# Unisense Apparels Ltd.

# Observations

# Discrepancies between drawings and on site condition

column layout.

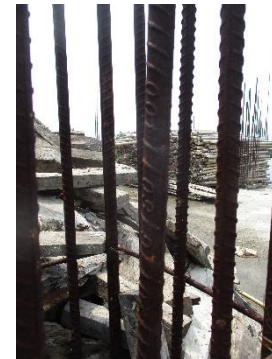
Column size and nos. of rebar & rebars dia are not fully match with column schedule. Building engineer is required confirm the dia, size & nos. of rebar on each column.

Shear walls are not shown in structural drawings which are exists on both lift core.

| Item No. | Observation                                                                                   | Recommended Action Plan                                                                                                                                               | Recommended Timeline |
|----------|-----------------------------------------------------------------------------------------------|-----------------------------------------------------------------------------------------------------------------------------------------------------------------------|----------------------|
| 1        | (Production Building)<br>Discrepancies between drawings and on site condition                 | Engage a qualified engineer for producing correct “as-built” drawings which reflect the actual site condition with complete structural and architectural information. | 6-weeks              |

Beam Layout

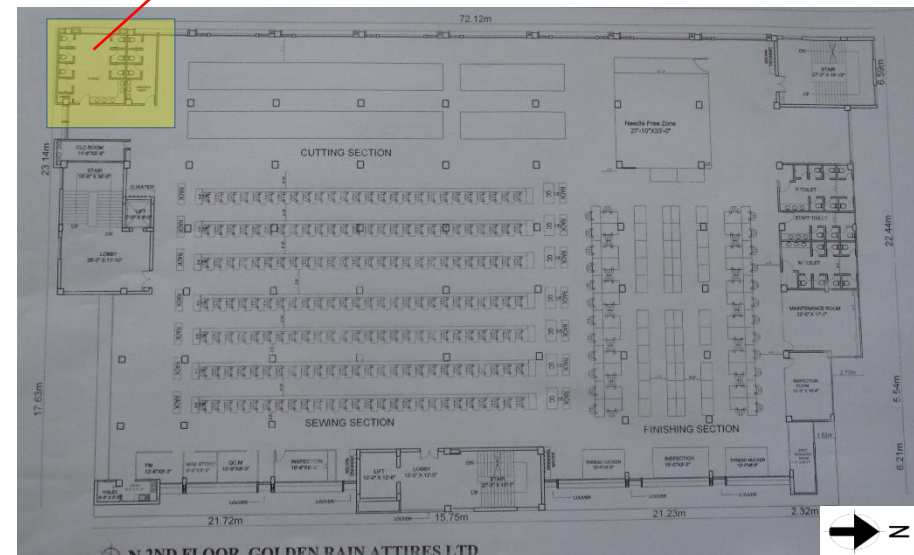
Minor mismatch in beam layout. Mismatch shown in red on beam layout.

Also some mismatch found in architectural drawings. Partition walls of toilet block at South-west corner does not match with layout plan.

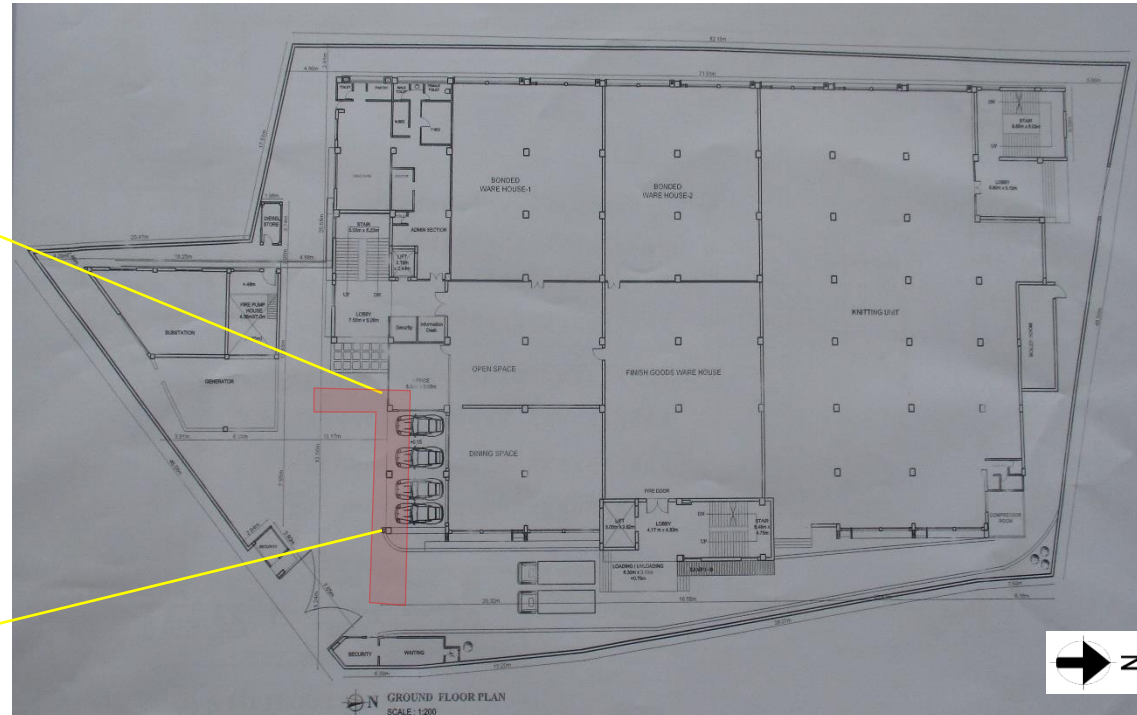
Water ponding found at current roof of the factory building. Also stacking of construction materials found almost every where at roof.

| Item No. | Observation                                                                                   | Recommended Action Plan                                                                                                                                               | Recommended Timeline |
|----------|-----------------------------------------------------------------------------------------------|-----------------------------------------------------------------------------------------------------------------------------------------------------------------------|----------------------|
| 4        | (Production Building)<br>Water ponding and stacking of construction material on roof          | For both durability and serviceability, waterproofing on the roof slab is recommended. Moreover the roof slab drainage system should be investigated.                 | 6-weeks              |
| 5        | (Production Building)<br>Water ponding and stacking of construction material on roof          | Remove construction materials from roof top.                                                                                                                          | 6-weeks              |
